# MEMORANDUM

Re: Requested design alterations for the proposed New Construction with Special Exceptions at 170 West 600 North / Petition #PLNHLC2018-00942 & PLNHLC2019-00111

## **ATTACHMENT A: REVISED NARRATIVE & PLAN SET**

### Front porch and glazing (south façade)

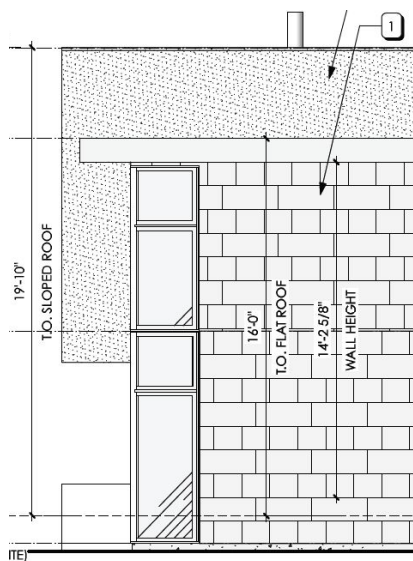
- Create a more defined front porch that is compatible with historic front porches seen on the block face;
- Amend the glazing on the front façade to be more compatible with window patterns typically seen on the block face and within the Historic Districts;
- Evaluate the need for an increased footprint for the accessory structure and return with a more compelling argument.

- Massing at front of home has generally remained the same, but the structure has been pushed back by approximately one foot (1') to create a more defined front porch:
  - Metal screen element with support column added above front entry way
  - Second-level roof canopy extended further out
  - Slab on grade made deeper to provide sitting area
  - Second metal planter added for a sense of enclosure for front porch
- Second-level balcony made deeper
- Mullion pattern on windows surrounding entry revised (upper transom-like delineation removed)

### **Building Footprints and Lot Coverage**

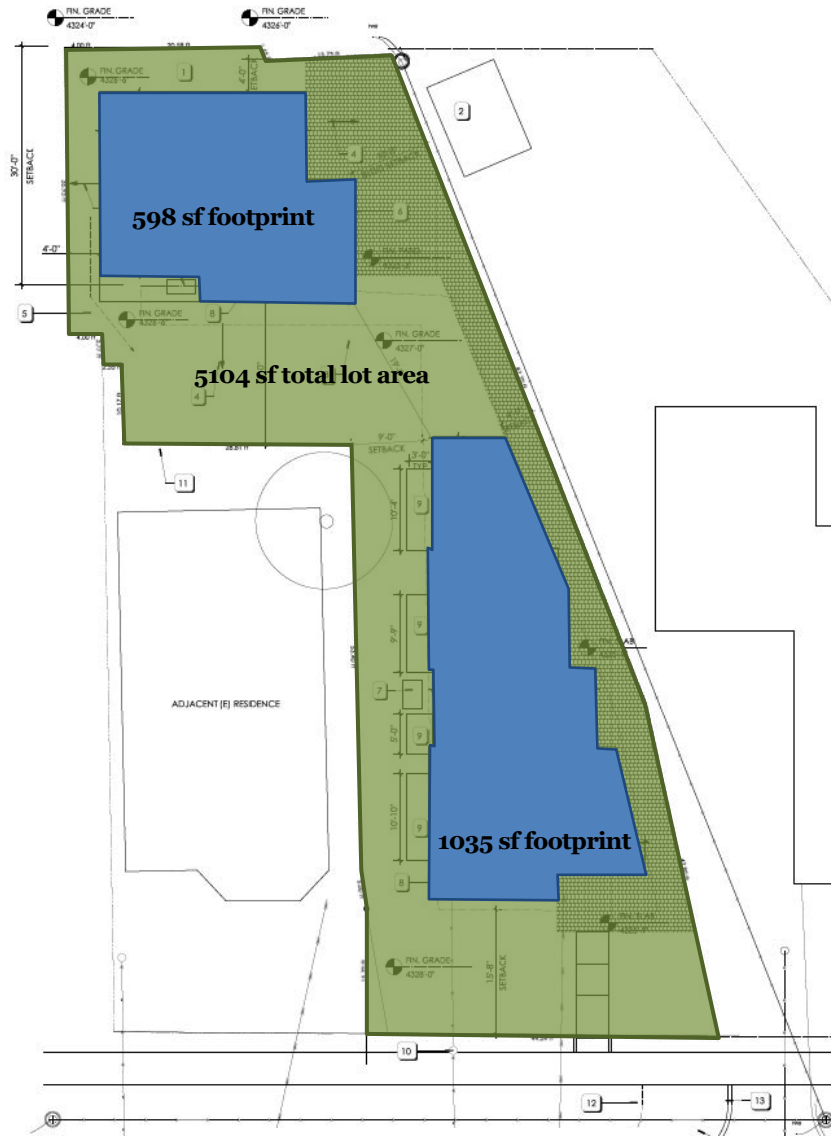
- Principal structure's footprint increased from 989 sf to 1035 sf with floor area added to rear of home
- ADU footprint decreased from 644 sf to 598 sf, which still exceeds the maximum permitted footprint of 50% of the footprint of the principal structure (517.5 sf).
- Overall building coverage of both principal and accessory structures remains at 32% of lot area (maximum permitted coverage is 40%)

The applicant's submitted narrative states, "In response [to the Commission's request], the principal dwelling footprint has been increased to 1035 SF, and the ADU footprint has been decreased to 598 sf, reducing the area ratio to 58%. Though this remains above 50%, we maintain that the unusual lot configuration, including a lot width of 40'-10" at the front setback and 24'-3" at the most narrow portion (11'-3" buildable width less setbacks), limits the primary residence footprint, and thus the primary/ADU ratio. Additionally, the owner wishes to preserve the open space in the rear yard rather than building the maximum house size allowed in order to increase the ADU footprint."

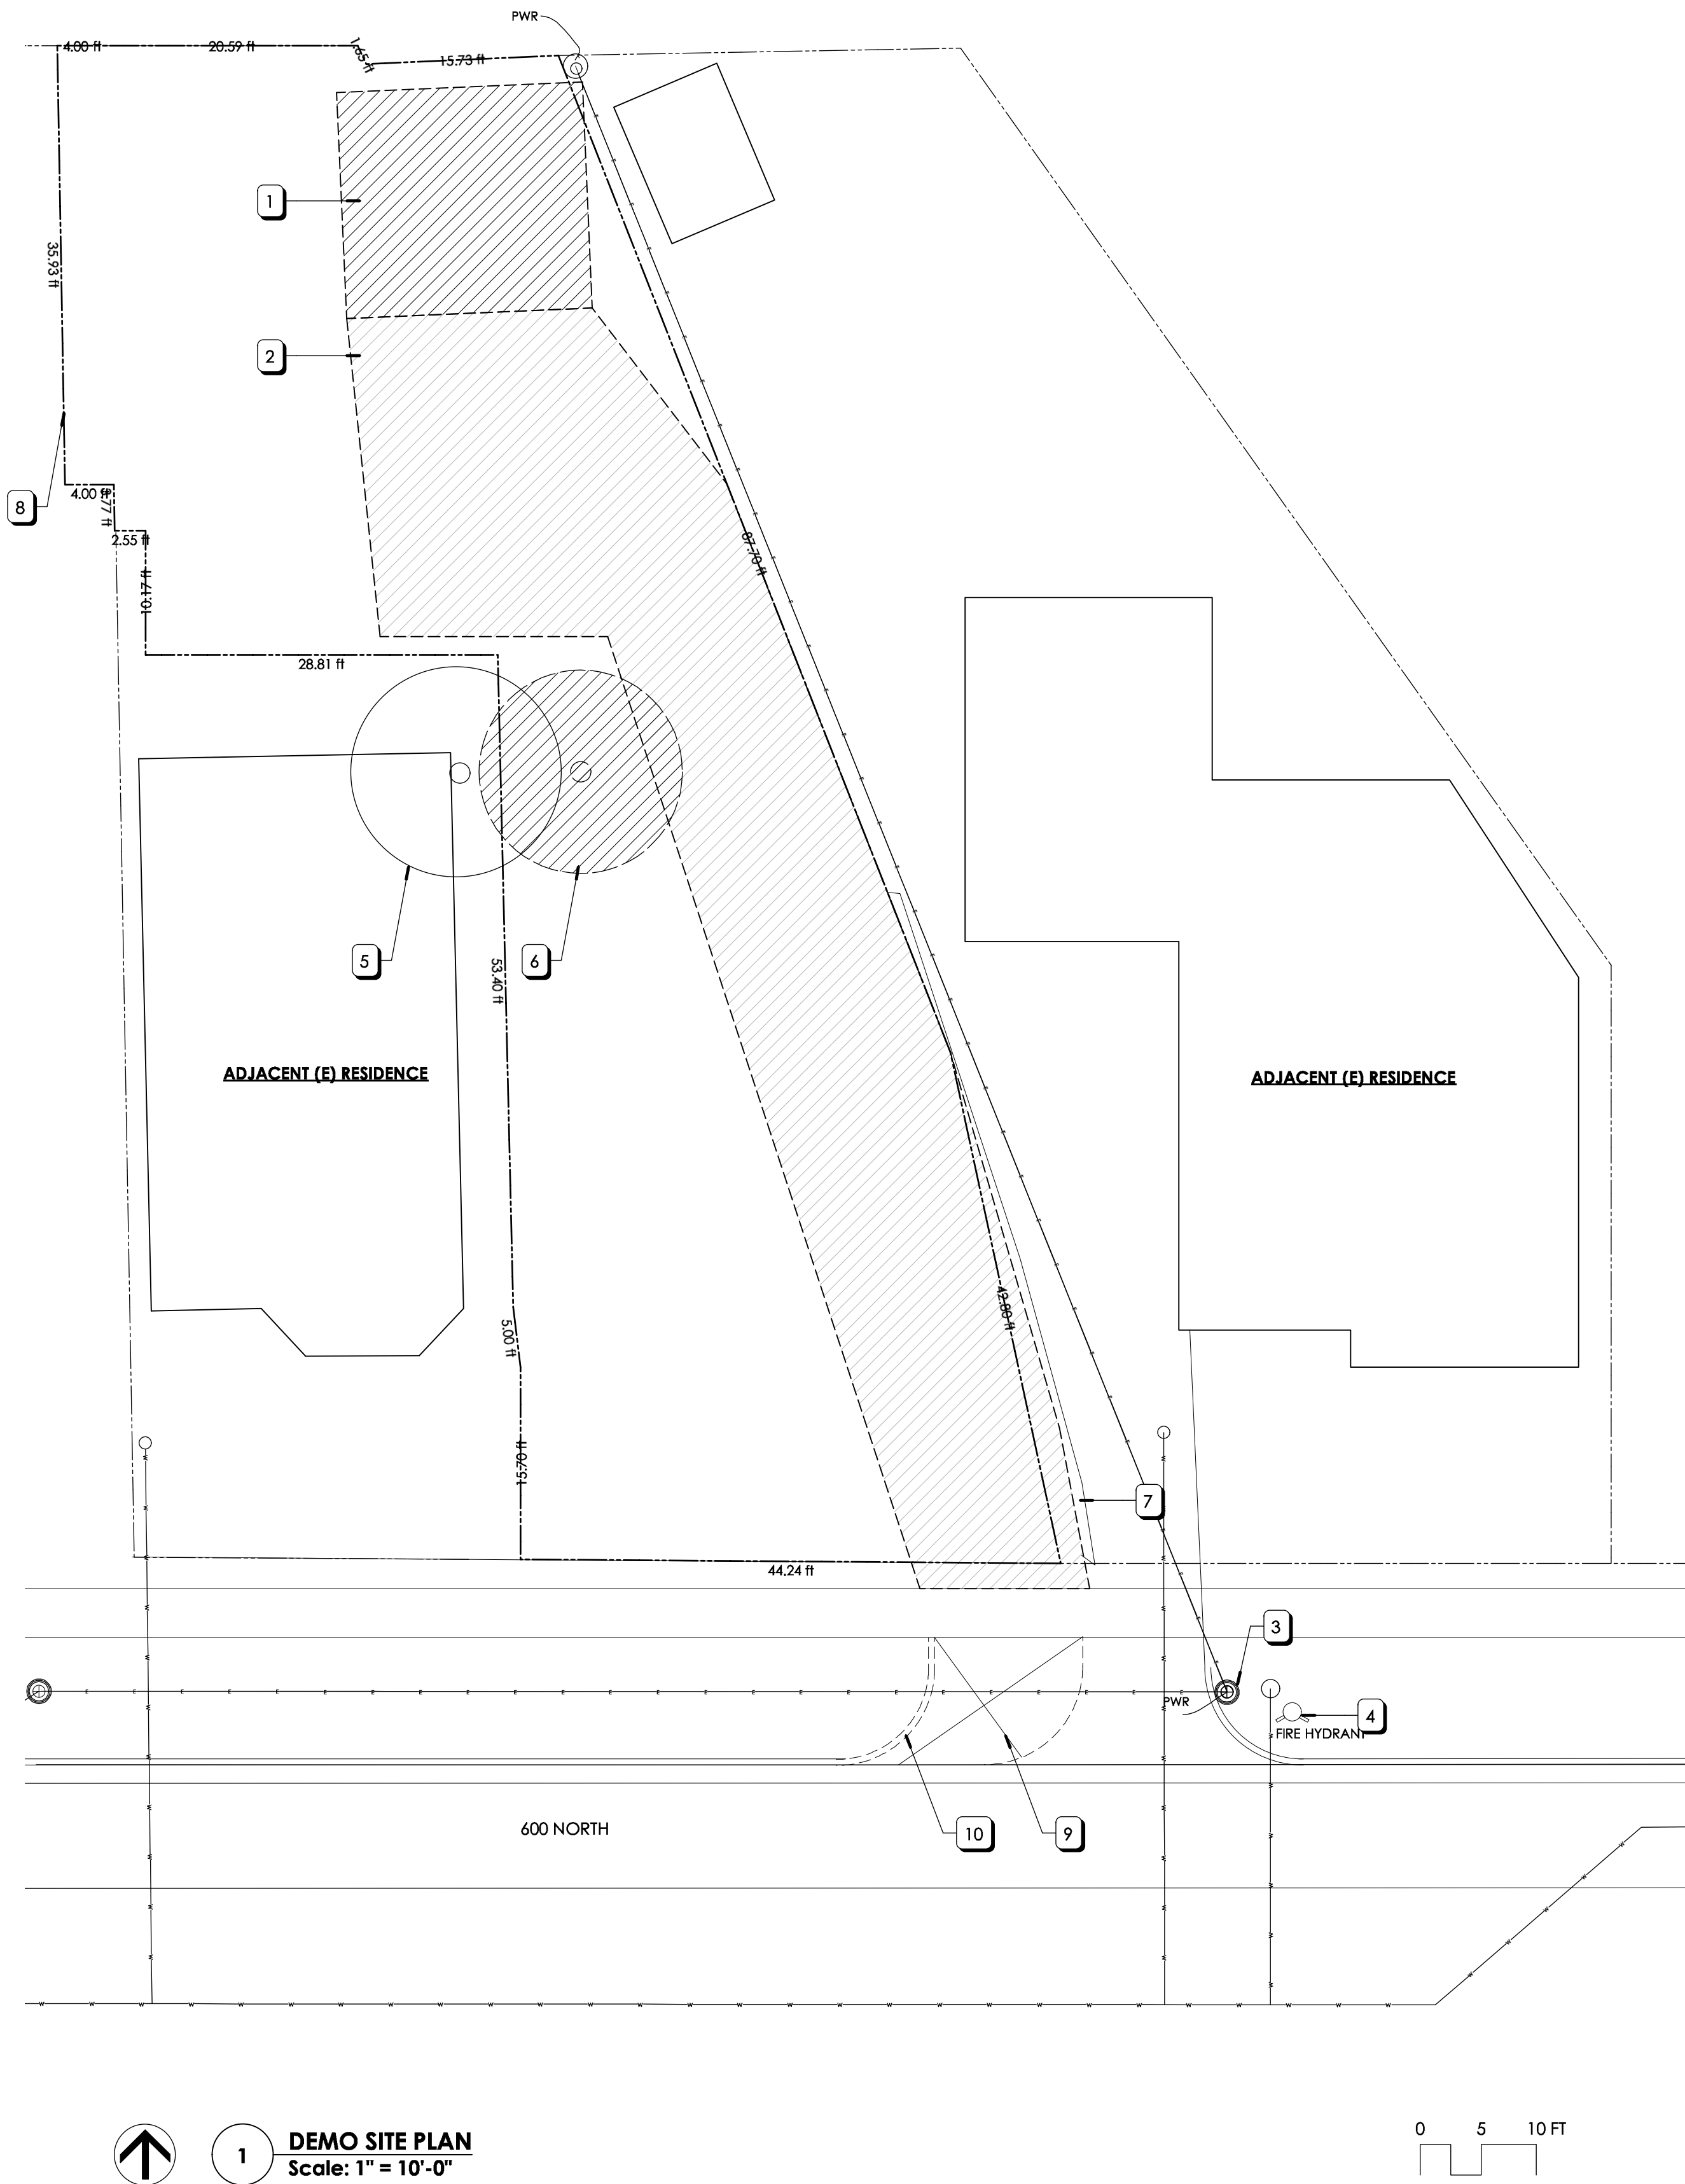
1. Per 21A.34.020.H.2.a(1), *Pedestrian: Safe pedestrian access is provided through architecturally highlighted entrances and walkways, consistent with patterns common in the historic context and the block face.* The majority of residences along the block face have entrances via a covered front porch—Staff recommends drawing inspiration from other entrances along the block face and introducing a modern version of the front entrance that has a covering at a human scale (i.e., just above human height).

- 1) **A metal screen element been introduced at the upper level to create a one story pedestrian scale appearance from the street, yet still allow natural light into the entry.**
- 2) **The home has shifted to the north by 12" to allow for a 4' covered extension over the porch as well as a deeper upper balcony from the living room.**
- 3) **Regarding HLC comment about a commercial versus residential appearance, the entry window mullion pattern has been revised, and a vertical mullion added at the corner.**
- 4) **The front porch extends beyond the covered area, to provide an extended sitting area, accommodating the intent and function of traditional porches. This is allowable in the front yard, per TABLE 21A.36.020B.)**
